**Validation report form for post-registration changes for
CDM project activities
(Version 02.0)**

Title and UNFCCC reference number of the project activity	Jilin Qianguo Qingshantou Wind Farm Project
Process track	<input type="checkbox"/> Prior approval <input checked="" type="checkbox"/> Issuance <input type="checkbox"/> Renewal of crediting period
Version number of the validation report on PRCs	01
Completion date of the validation report on PRCs	27/11/2018
Type(s) of PRCs	<input type="checkbox"/> Temporary deviations from the registered monitoring plan, monitoring methodology or standardized baseline <input checked="" type="checkbox"/> Corrections <input type="checkbox"/> Changes to the start date of the crediting period <input type="checkbox"/> Inclusion of a monitoring plan to a registered project activity <input checked="" type="checkbox"/> Permanent changes from registered monitoring plan, monitoring methodology or standardized baseline <input type="checkbox"/> Changes to the project design of a registered project activity <input type="checkbox"/> Types of changes specific to afforestation and reforestation project activities

Shenzhen CTI International Certification Co., L

Fig 1 Comparison of the monitoring system between the registered PDD and Revised PDD

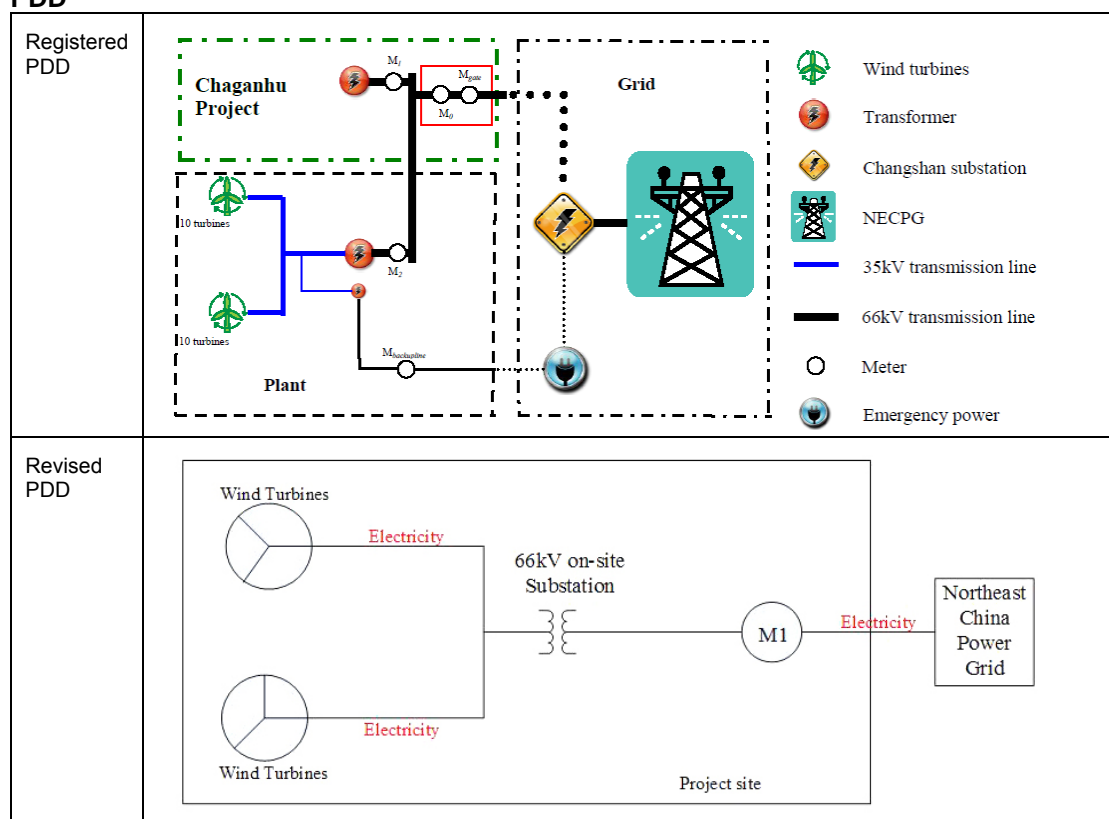
As per the registered monitoring plan, two bi-directional meters (M_{gate} , M_0) will be installed to monitor $EG_{export,y}$ and $EG_{import,y}$. M_0 works as backup meter for M_{gate} when there is failures in M_{gate} , M_0 will be used. After another wind farm plant – Chaganhu project is connected to the same on- site substation, the M_{gate} and M_0 will be used to monitor electricity imported and exported from both two projects. Then, M_1 which monitors electricity from the proposed project will be implemented with M_2 which monitors electricity from Chaganhu project to calculate the exported and imported electricity from the proposed project as $M_{gate} \cdot M_1 / (M_1 + M_2)$. In order to monitor the electricity imported for black start, one meter ($M_{backupline,y}$) will be installed to monitor $EG_{backupline,y}$. The accuracy of all the meters must be 0.5 or higher which means the error resulting from such equipment shall not exceed $\pm 0.5\%$ of full-scale rating.

After the proposed project registered, it has been operated completely on 21/07/2013. As per the requirement of the Grid Company /4/, a electricity meter (M_1) has been installed at high volt side of 66kV on-site Substation to monitor the electricity supplied to NECPG by the proposed project ($EG_{export,y}$) and the electricity imported from NECPG by the proposed project ($EG_{import,y}$) (as shown= in Fig 1 below).

Corresponding to the changes of the monitoring structure, the monitoring for the parameters $EG_{export,y}$ (electricity exported to the grid by the project) and $EG_{import,y}$ (electricity imported from the grid to the project) changed from directly measured by the meter M_1 installed at the high volt side of 66kV on-site Substation to be calculated based on the measured values of the meters as below:

Findings	<p>CAR 2: “In the registered PDD, two bi-directional meters (M_{gate}, M_0) will be installed to monitor $EG_{\text{export},y}$ and $EG_{\text{import},y}$. M_0 works as backup meter for M_{gate} when there is failures in M_{gate}, M_0 will be used. After another wind farm plant – Chaganhu project is connected to the same on- site substation, the M_{gate} and M_0 will be used to monitor electricity imported and exported from both two projects. Then, M1 which monitors electricity from the proposed project will be implemented with M2 which monitors electricity from Chaganhu project to calculate the exported and imported electricity from the proposed project as $M_{\text{gate}} \cdot M1 / (M1 + M2)$. In order to monitor the electricity imported for black start, one meter ($M_{\text{backuptime}}$) will</p>

be installed to monitor EG _{backuptline, y} . The accuracy of all the meters must be 0.5 or higher which means the error resulting from such equipment shall not exceed $\pm 0.5\%$ of full-scale rating". However, by on-site visit, CTI found that a meter (M1) has been installed at the high volt side of 66kV on-site Substation to monitor the total electricity supplied to the grid by the proposed project and the imports from the grid by the proposed project.(Refer to Appendix 4)
Conclusion	CTI confirms that the post-registration changes comply with the relevant requirements related to the permanent changes from the registered monitoring plan in the CDM project standard for project activities (Ver. 1.0) and do not require the prior approval by the EB.

CAR ID	02	Section no.	D.6	Date: 20/11/2018
Description of CAR				
“In the registered PDD, two bi-directional meters (M_{gate} , M_0) will be installed to monitor $EG_{export,y}$ and $EG_{import,y}$. M_0 works as backup meter for M_{gate} when there is failures in M_{gate} , M_0 will be used. After another wind farm plant – Chaganhu project is connected to the same on- site substation, the M_{gate} and M_0 will be used to monitor electricity imported and exported from both two projects. Then, M_1 which monitors electricity from the proposed project will be implemented with M_2 which monitors electricity from Chaganhu project to calculate the exported and imported electricity from the proposed project as $M_{gate} \cdot M_1 / (M_1 + M_2)$. In order to monitor the electricity imported for black start, one meter ($M_{backupline}$) will be installed to monitor $EG_{backupline,y}$. The accuracy of all the meters must be 0.5 or higher which means the error resulting from such equipment shall not exceed $\pm 0.5\%$ of full-scale rating”. However, by on-site visit, CTI found that a meter (M_1) has been installed at the high volt side of 66kV on-site Substation to monitor the total electricity supplied to the grid by the proposed project and the imports from the grid by the proposed project.

<p>The actual accuracies of meter installed is verified to be 0.2S for M1, in compliance with the calibrating standards “Verification Regulation of Electrical Energy Meters with Electronics (JJG596-2012)”. The calibration frequency of meters is annual, which is consistent with the information in the PDD.</p> <p>By document review and on site investigation, CTI confirms that:</p> <ul style="list-style-type: none"> the accuracy of the meter M1 meets the requirement of the registered and Revised monitoring plan; the monitoring means of $EG_{\text{export},y}$ and $EG_{\text{import},y}$ is reasonable. <p>The PDD has been revised to indicate the changes from the registered monitoring plan. Through the on-site investigation and the document review, the Verification Team has confirmed that the actual monitoring structure is in accordance with the Power Purchase Agreement /4/ and revised monitoring plan reflects the actual project information.</p> <p>As per the CDM project standard for project activities (Ver.1.0), a request for approval of a post-registration change may be suitable to be submitted under the issuance track:</p> <ol style="list-style-type: none"> Any corrections to project information¹ of a registered clean development mechanism (CDM) project activity that do not affect the design of the project activity; Temporary deviations from the registered monitoring plan for which alternative monitoring arrangements are proposed, if the proposed alternative monitoring arrangements produce a conservative estimate of greenhouse gas (GHG) emission reductions or net anthropogenic GHG removals; Changes to the monitoring of a registered CDM project activity that have no material impact on the applicability of the applied methodologies or the accuracy and completeness of the monitoring; Changes to the project design of a registered CDM project activity that do not adversely impact any of the following: <ol style="list-style-type: none"> The applicability and application of the applied methodologies and, where applicable, the applied standardized baselines with which the project activity has been registered; The additionality of the project activity; The scale of the project activity. Changes to the project design to use the positive list for demonstrating additionality in the latest valid version of the “Methodological tool: Demonstration of additionality of small-scale project activities” or the “Methodological tool: Demonstrating additionality of microscale project activities”; The types of changes listed in the “Guidelines on accounting of specified types of changes in A/R CDM project activities from the description in registered project design document”. <p>As stated above, the changes of the proposed project are only related to the changes on the quantity and location of the monitoring equipment (i.e. the meters need to be installed at the 35kV transmission lines of each project for cutting the quantity of total electricity of two projects as per the requirement of PPA. It considers the changes belongs to the item (c), thus the proposed changes do not require the prior approval by the EB. CTI confirms that the changes do not affect the application of the applied methodology and do not reduce the level of accuracy and completeness of the monitoring compared with the requirements contained in the registered monitoring plan. And also the changes do not lead to a reduction in the accuracy of the calculation of emission reductions.</p>

Project participant response				Date: 22/11/2018
There are permanent changes to the registered monitoring plan, Changes that are being submitted with this monitoring report as part of the request for issuance (post-registration change - issuance track) as applicable from this monitoring period.				
Documentation provided by project participant				
Diagram of power connection system

DOE assessment	Date: 23/11/2018
<p>The Revised PDD has been provided by PP to indicate the permanent changes in the monitoring system. The Verification Team confirms the updated monitoring system is consistent with the actual condition and according to the requirement of the Grid Company. As per the Ver.1.0 of CDM project standard for project activities, these changes do not need to get the prior approval from EB. Therefore, the Revised PDD will be submitted following the verification documents.</p> <p>CAR 2 is closed.</p>
